## ADDENDUM NO. 2

DATE: February 10, 2025

PROJECT: ORCHARD VALLEY GOLF COURSE BRIDGE REPLACEMENTS

FROM: Engineering Enterprises, Inc.  
52 Wheeler Road  
Sugar Grove, Illinois 60554

DATE:  
 PROJECT NO:  
 ORCHARD VALLEY CONC' APPROACH SLAB DTL  
 SHEET **S12** OF **13**

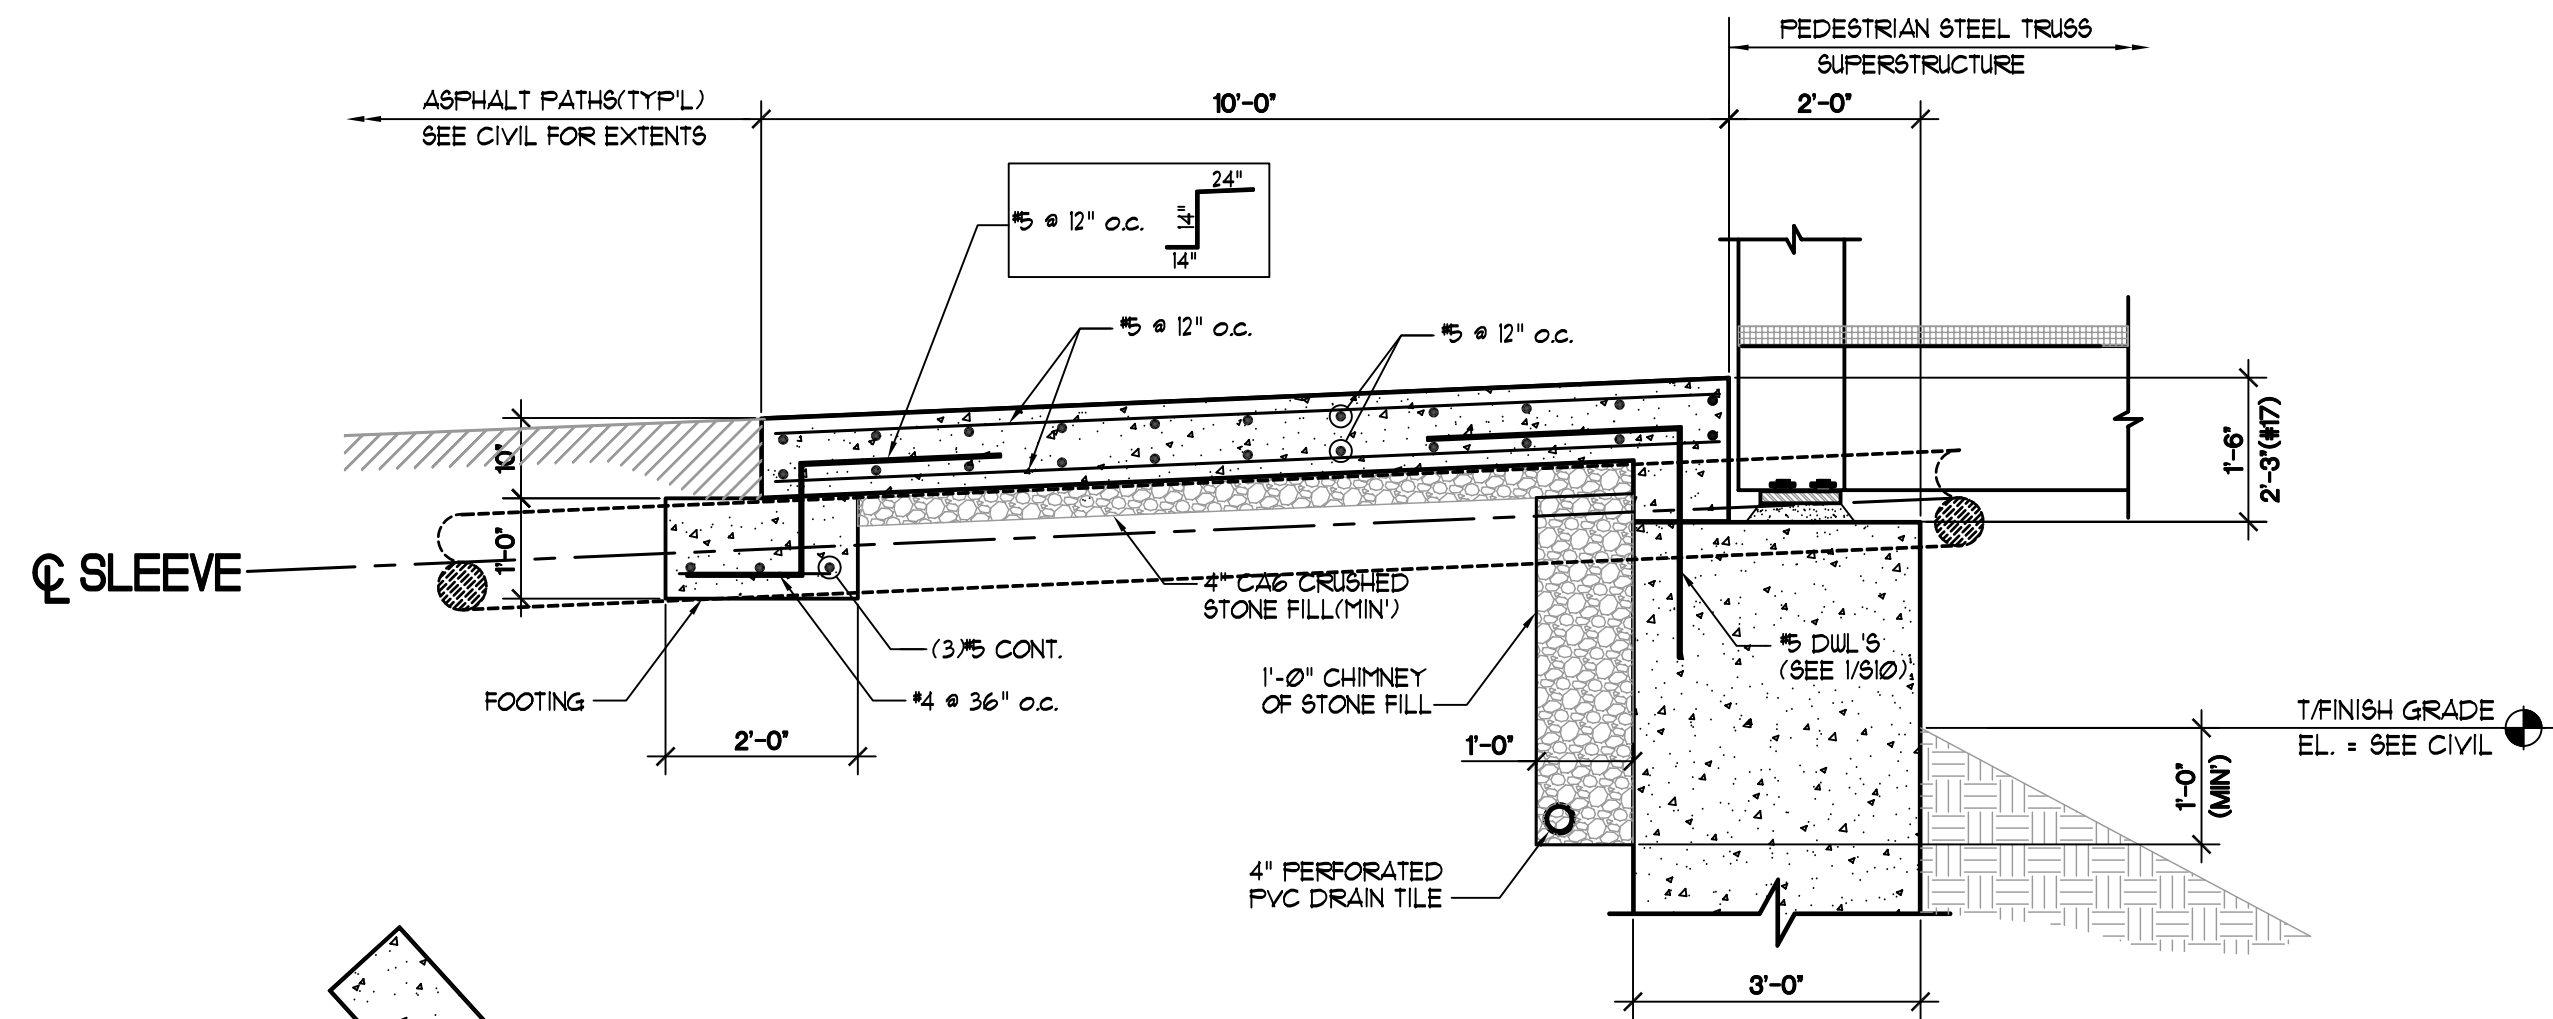
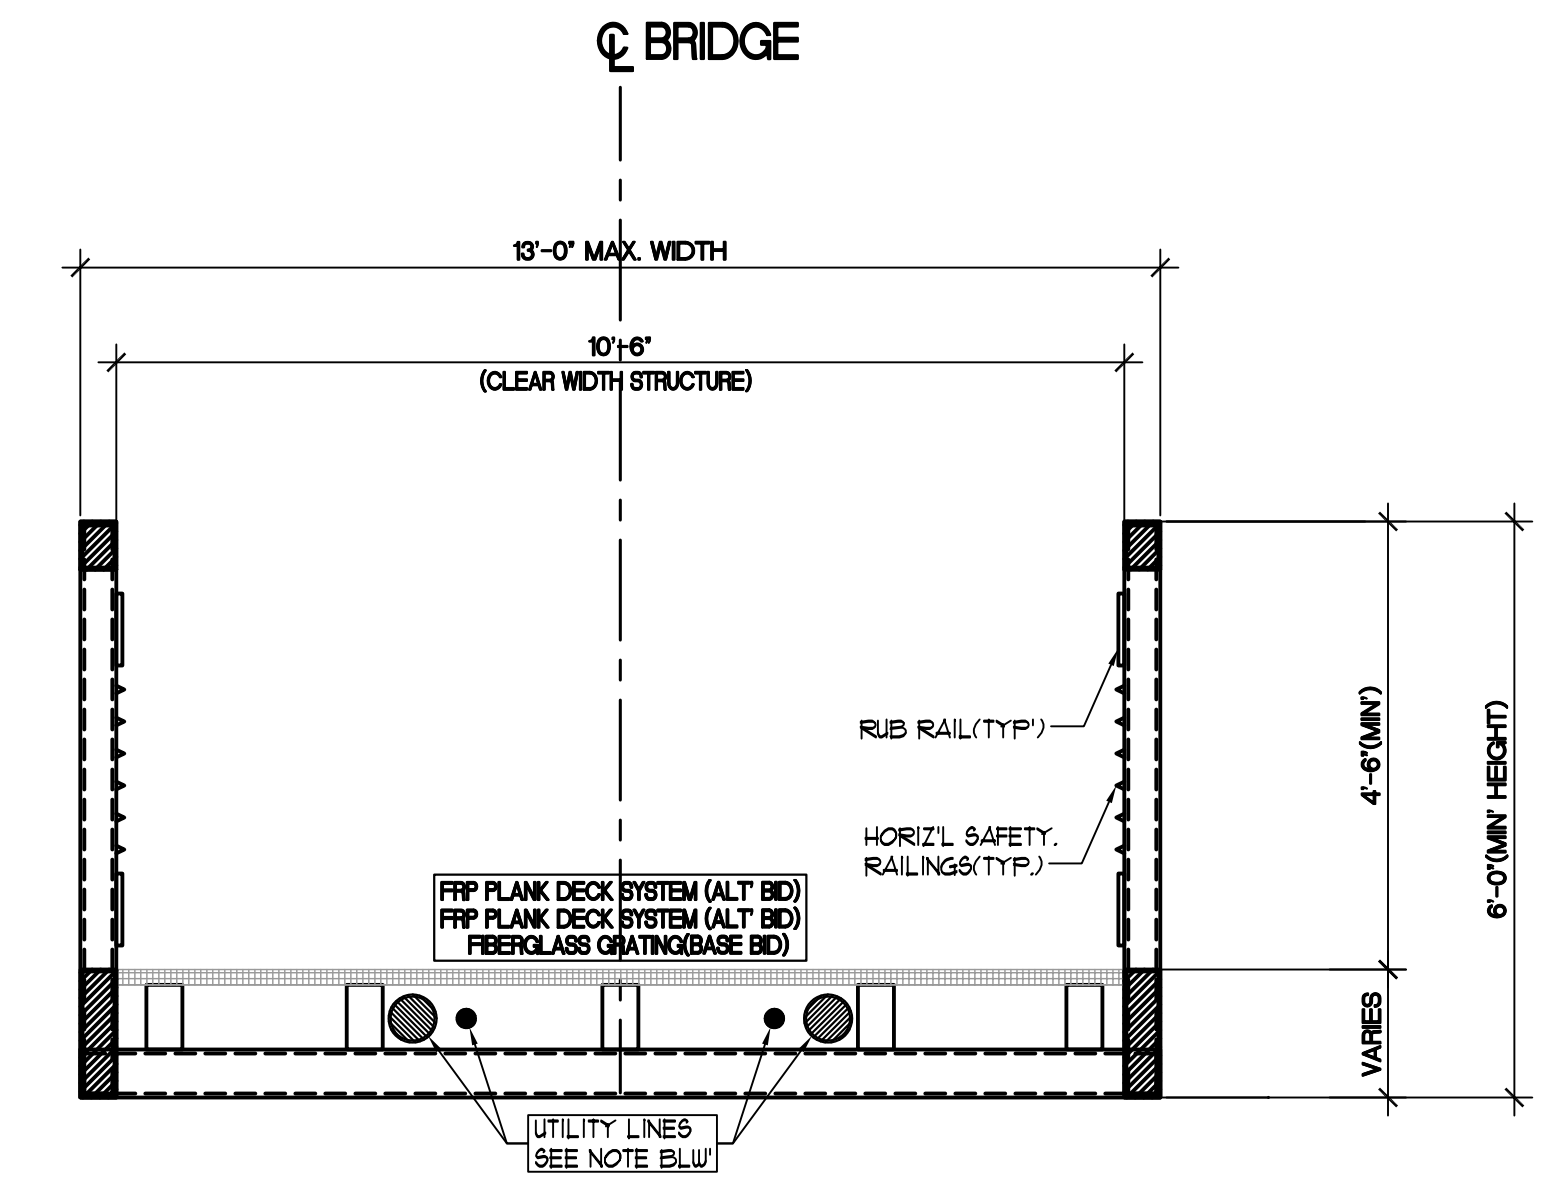
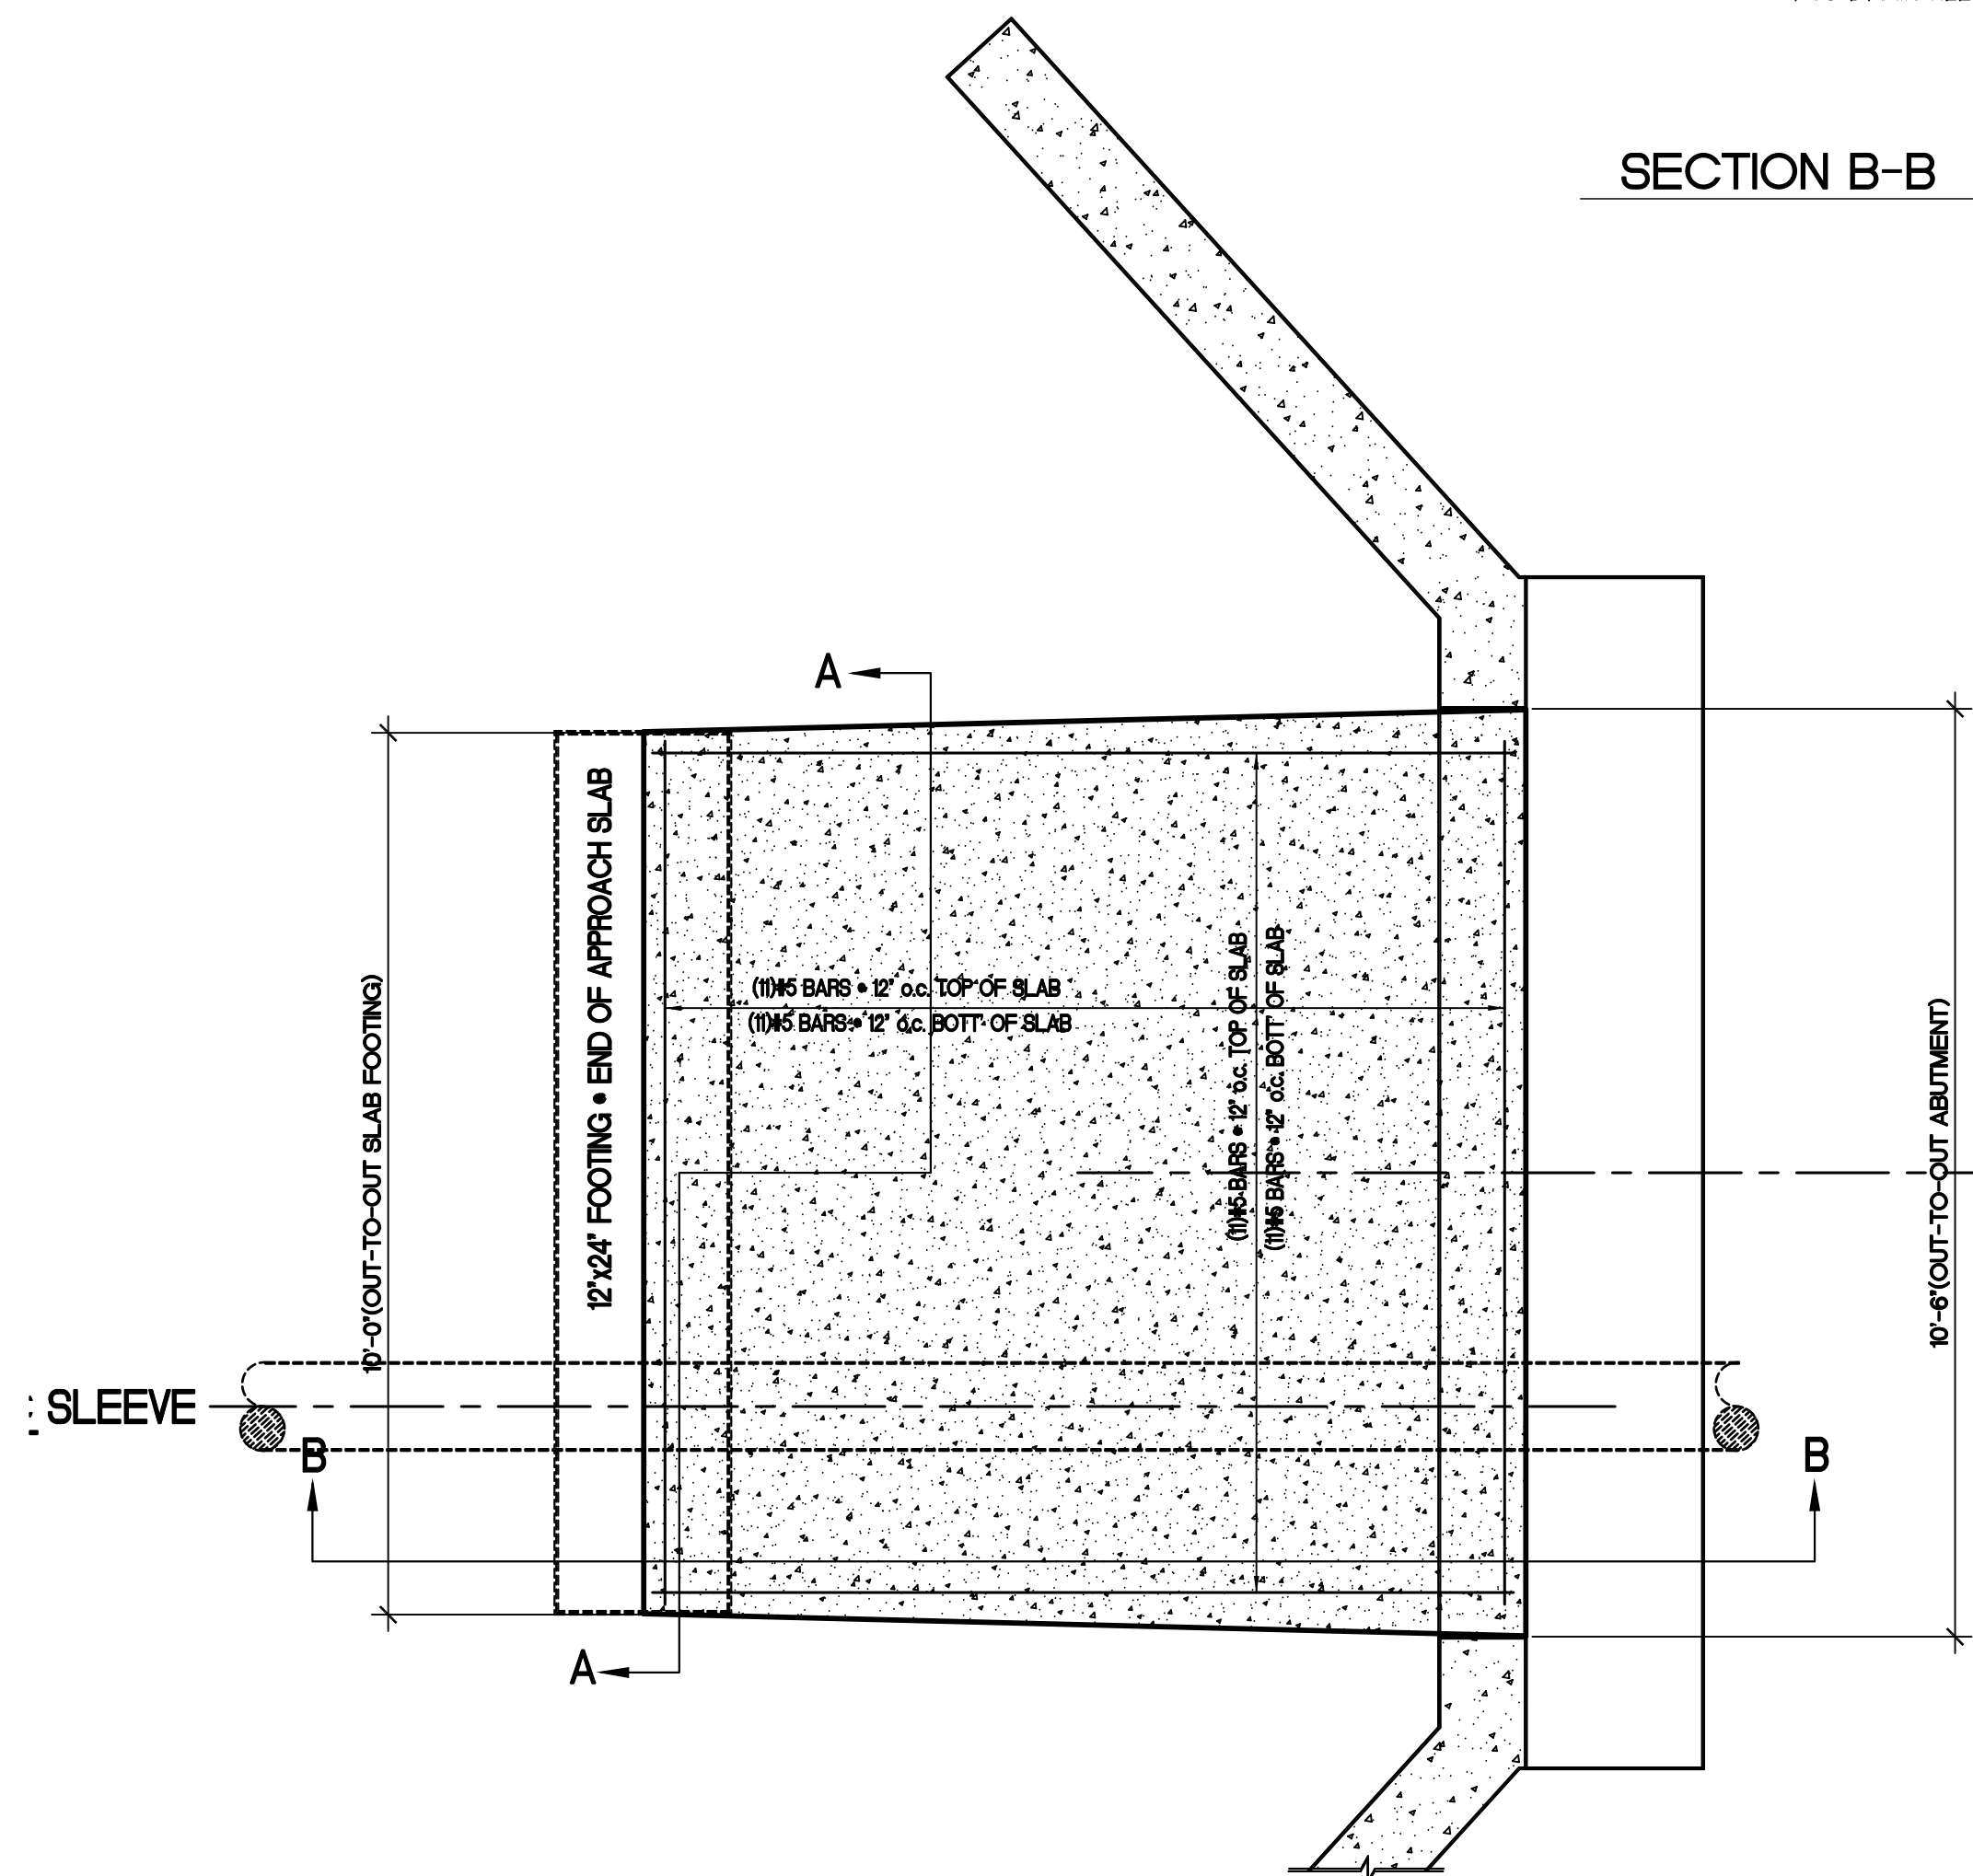
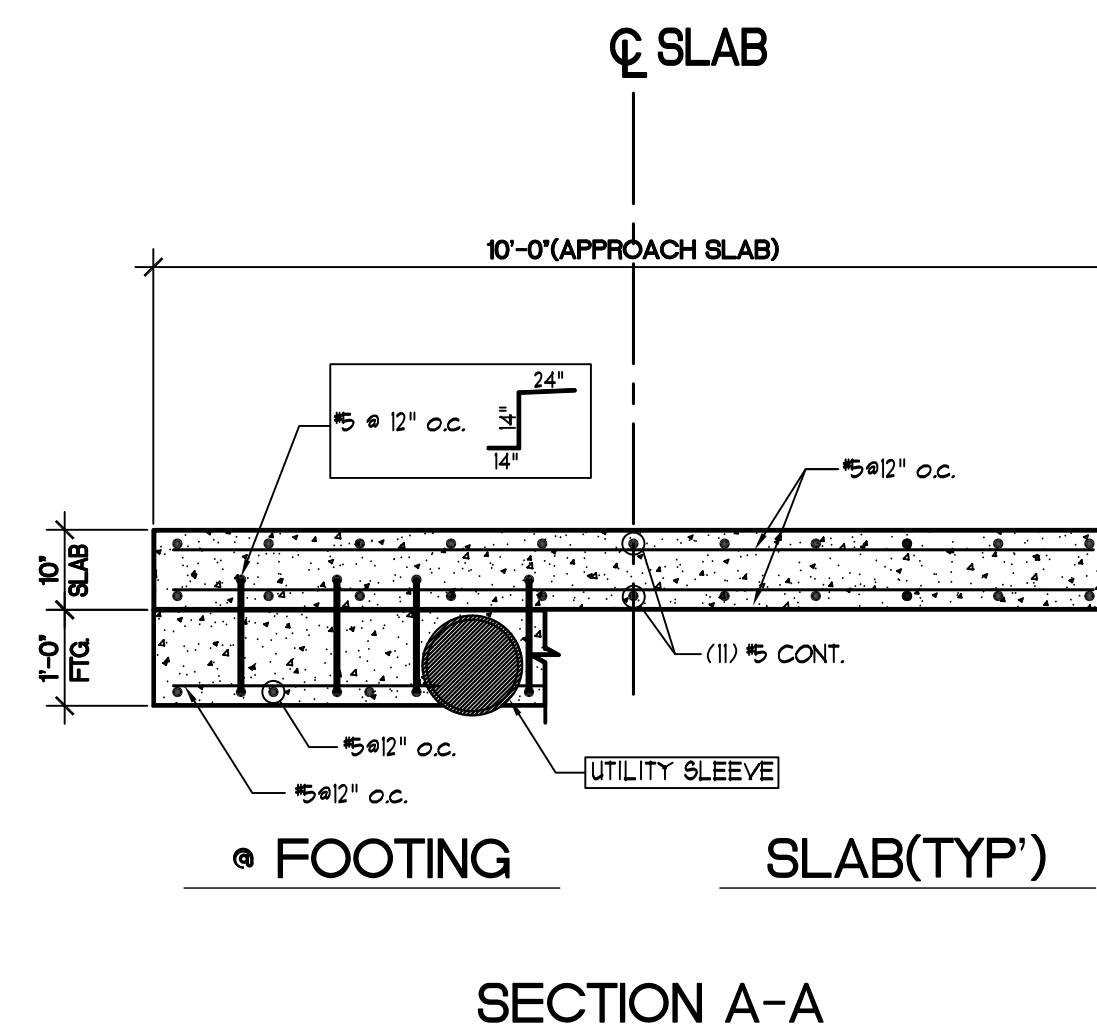
14. **Question 14:** *Is the concrete backwall height adjustable? I see issues trying to get a 151' bridge and an 83' bridge to have the same depth-of-section and backwall height.*

**Response to Question 14:** Yes. See sheet S12.

**BRIDGE UTILITY NOTE:**  
 BRIDGES TO SUPPORT WATER/COMMUNTY (4"-10" @ WATER/2" @ COMMUNTY) LINES. PROVIDE ANCHORAGE OF UTILITIES TO UNDERSIDE OF THE BRIDGE STRUCTURE. METHOD OF ANCHORAGE TO BE APPROVED BY FOX VALLEY PARK DISTRICT AND CIVIL/STRUCTURAL ENGINEERS (\*\*ANTICIPATE 2 LINES).

WATER LINE - HDPE DR 11 MATERIAL
